# ***AM572x Sitara™ Processors Silicon Revisions 1.1, 2.0***

## ***Errata***

Literature Number: SPRZ429N  
JULY 2014 – REVISED JULY 2024

**Figure 2-2. Simplified SoC 192-MHz Mode DLL Block Diagram**

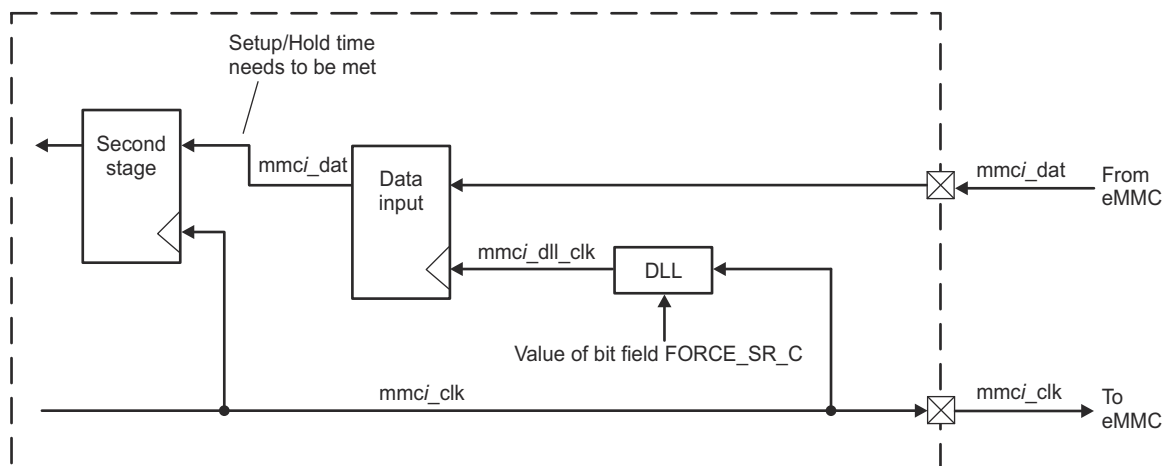
Internal to the MMC module, a second stage latch is used to recapture data captured by DLL delayed CLK, MMC\_DLL\_CLK. The second stage latch captures with the original transmitting clock, MMC\_CLK.

MMC\_DLL\_CLK and MMC\_CLK both run at the same clock frequency. This results in a narrow range of tuning ratio elements, where the delayed MMC\_DLL\_CLK comes in phase with MMC\_CLK. If the clocks are in phase, the data captured by the first clock violates the setup and hold time requirements needed for the second stage latch, resulting in incorrectly read data. This is known as tuning re-timing errors.

**Figure 4-1. PAB\_RevA**

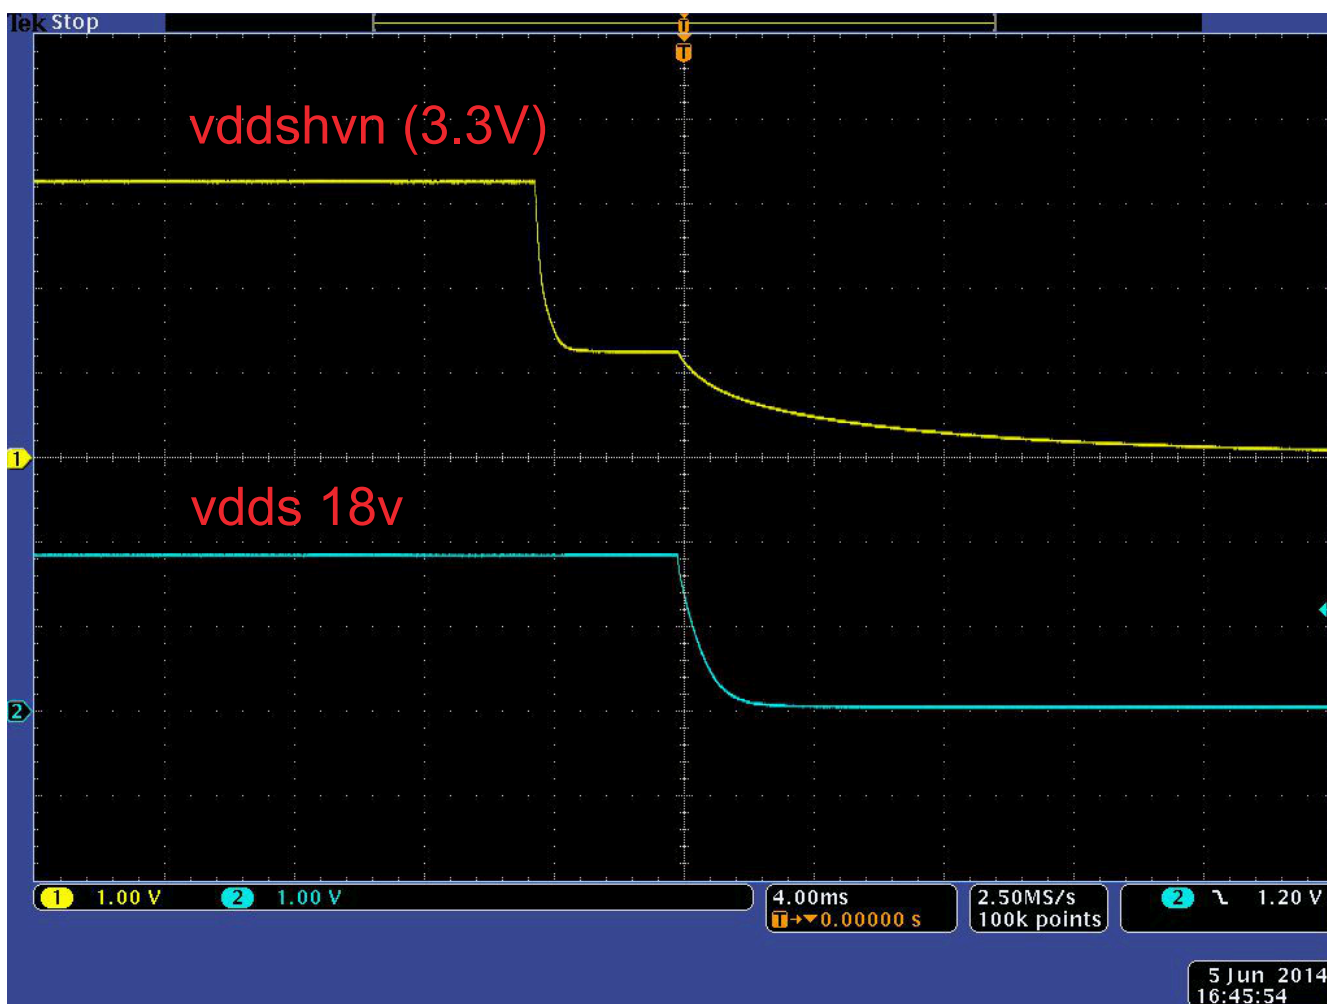
The Data Manual allows the vddshvn rail (in either 3.3V or 1.8V mode) to power down at the same time or before the vdds18v rail. When the vddshvn rail is powered down before the vdds18v rail, the vddshvn rail stays at Plateau Level (<1.5V) until the vdds18v rail is disabled, as shown in the waveform below.

A subset of the SOC's LVCMOS IOs (refer to DM for details) have a pull-up resistor that is active by default, including during reset and power-down. The SOC's IOs that have internal or external pull-ups will stay at Plateau Level (<1.5V) during the power-down. If other ICs on the board that are interfaced to the SOC's LVCMOS signals use a separate supply then it's possible that the other IC's signals can be pulled to the Plateau Level while its power supply is off.

The root cause of the plateau is related to the LVCMOS IO buffer Dual Voltage detection circuitry. The LVCMOS Dual Voltage IO includes voltage comparator circuitry to determine

For systems that use a different 3.3V supply for the SOC and connected ICs, customers should evaluate their system for reliability risk. If necessary, the PMIC OTP power-down sequence can be modified to delay the vddshv[11:1] powerdown to coincide with the vdds18v powerdown. [Note: The 3.3V rail must never be 2.0V above the 1.8V rail.]

**Figure 4-2. Leakage Voltage**

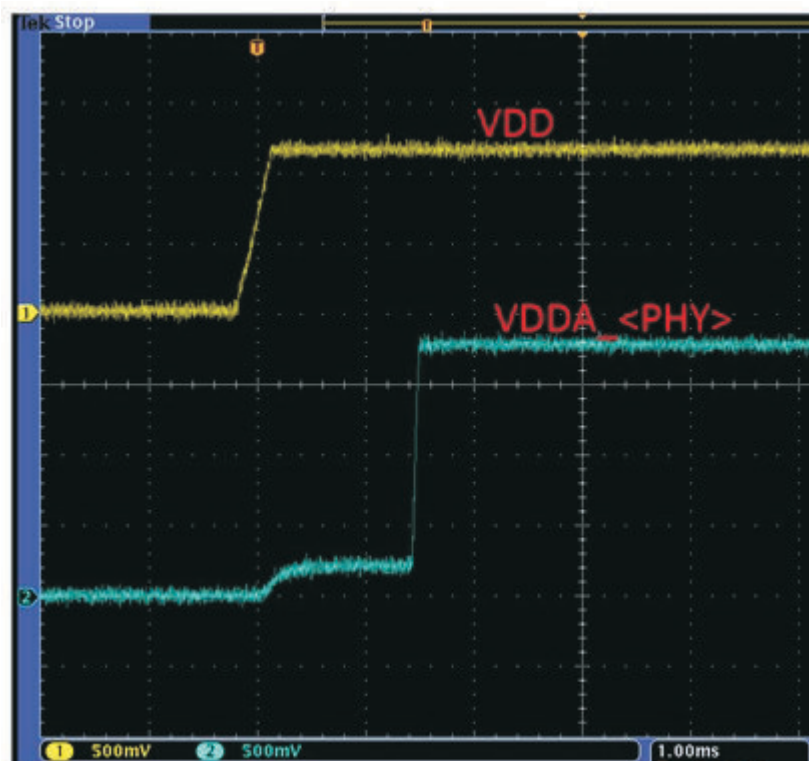
A current path exists between VDD and the high speed analog PHY domain (VDDA\_HDMI, VDDA\_PCIE, VDDA\_SATA, VDDA\_USB2/3) during the supply power up and power down sequences.

The device-specific Data Manual requires Core AVS rail (VDD) to power up before the 1.8 V high speed analog PHY domain(s). When this sequence is followed, the high speed analog PHY domain will have a small step-up to a voltage plateau (< 0.5 V) that aligns to the beginning of the VDD ramp-up, and is maintained until the ramp-up of high speed analog PHY rail, as shown in [Figure 4-2](#). Note the leakage value will differ from system to system, but will be less than 500 mV. The leakage voltage in the provided capture is approximately 250 mV.

A similar condition exists during supply power down sequence. The high speed analog PHY domain(s) are required to be powered down prior to Core AVS rail (VDD), and may cause a small plateau to exist until Core AVS rail (VDD) is ramped down.
